Metropolitan Development Commission Regional Center Hearing Examiner (May 9, 2024) Meeting Agenda

STAFF REPORT

Case Number	2024-REG-016
Address (approx.)	501 Indiana Avenue
Location	Center Township, Council District # 12
Petitioner	Indiana Avenue Partners, LLC., by Chris Mulloy
Zoning	CBD-2 (RC)
Request	Regional Center Approval to provide for: <ol style="list-style-type: none"> 1. Demolition of an existing office structure, and, 2. Construction of a 12-story mixed-use development, consisting of 263 dwelling units, 323 parking spaces within a parking garage, and approximately 35,475 square feet of amenity space, office space, and retail space.

SHEET NO. C-101

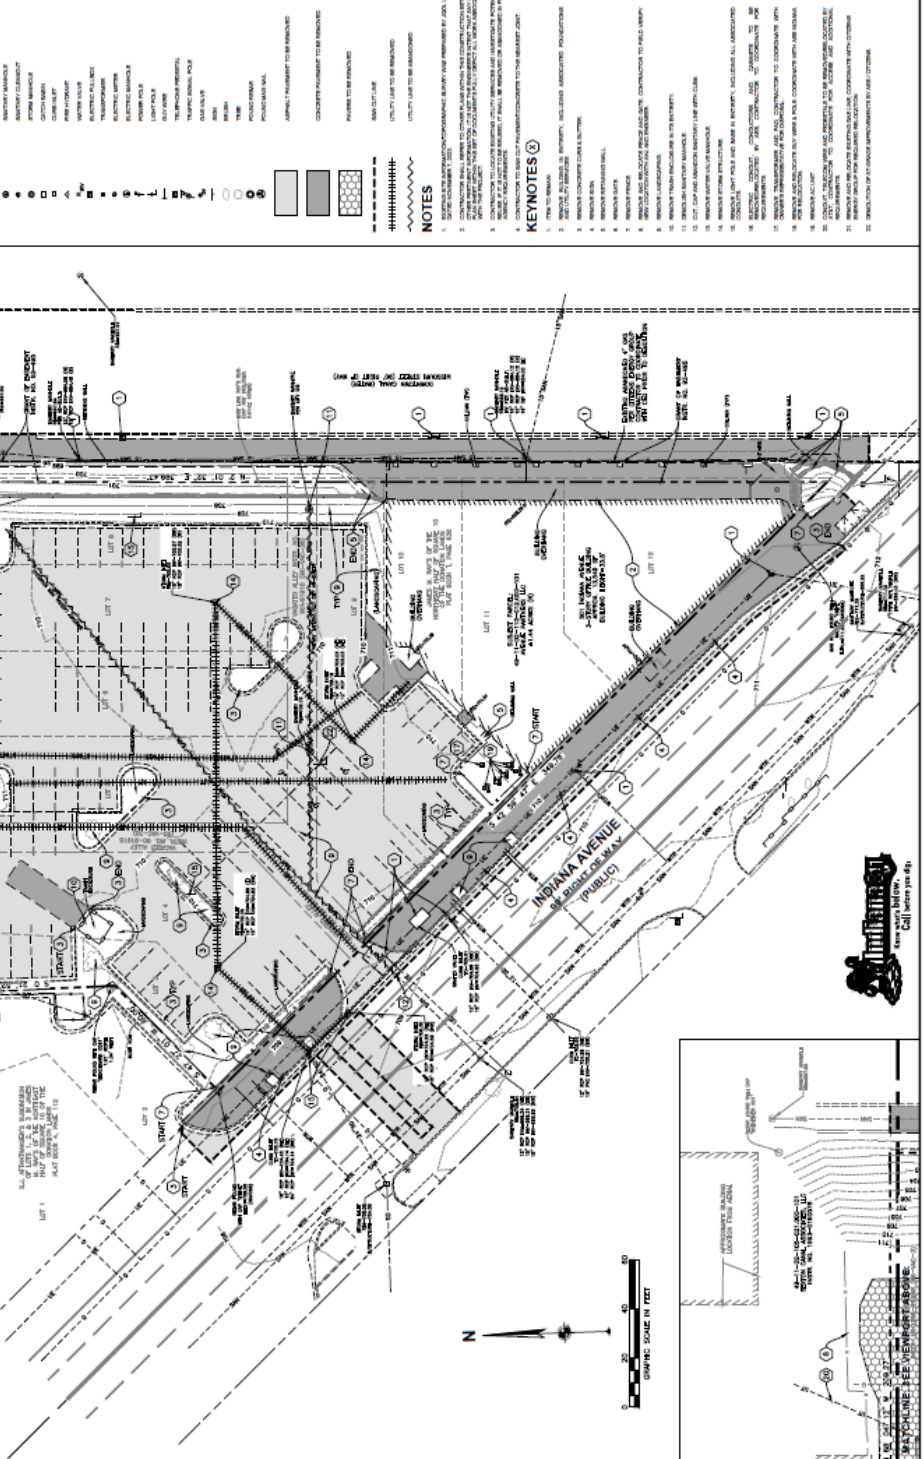
Part One would demolish the existing office building that was constructed in 1991, with the design of the structure approved via a 1991 Regional Center Approval petition (91-AP-173).

A portion of the existing structure, along the Central Canal, is within public right-of-way. An easement was granted by the City in late 1991 (Instrument No.: 920000495) for construction within this right-of-way. This easement is specific to the developer and former property owner of the existing structure and is non-transferrable to the current property owner. The City has determined that a 'Right of Entry' must be granted by the City in order for the current property owner to demolish the portion of the building within this easement area. As of this writing, it is staff's understanding that this document is being prepared.

Review of the Guidelines against the submitted plans for Part One indicate that the request would meet the minimum Guidelines requirements.
